Gen 5 FLOCS Hose Relocation

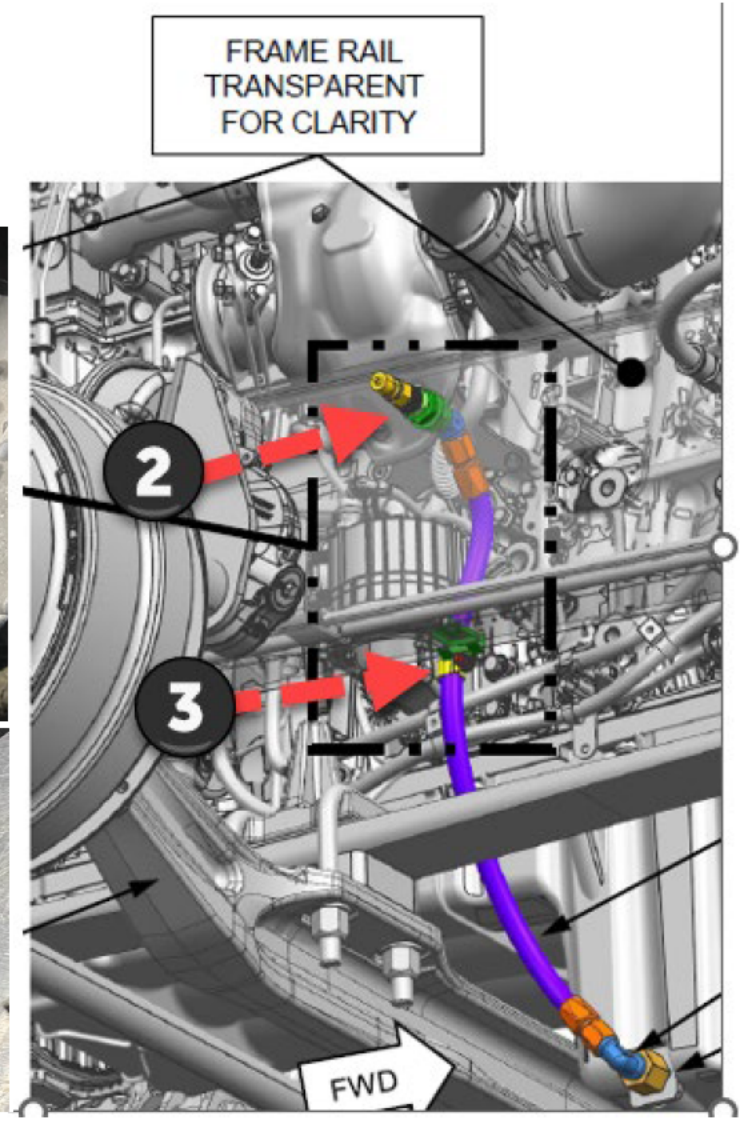
- Gen 5 engines use molded drain insert – prior engines used treaded drain plug insert
- Increased failures with molded insert
- Freightliner released SS-3164. Relocate hose bracket from frame to engine, reduce stress
- Required Parts:
  - From Freightliner
    - 18-72639-000 (bracket lower) Qty 1
    - 23-09528-147 (P Clamp) Qty 1
    - 23-13345-020 M8x1.25x20 (Bolt for lower bracket) Qty 1
  - From stock
    - IMP-9144 (Blue Loctite)
    - Thread sealer
    - Nuts and bolts from imperial (to secure P Clamp to bracket)
    - M6x1.00x30mm (Imperial 12122)
    - M6-1.00 Nut (Imperial 12402)
    - M6 flat washer (Imperal12602) Qty 2
    - M6 Lock Washer (Imperial 12702)
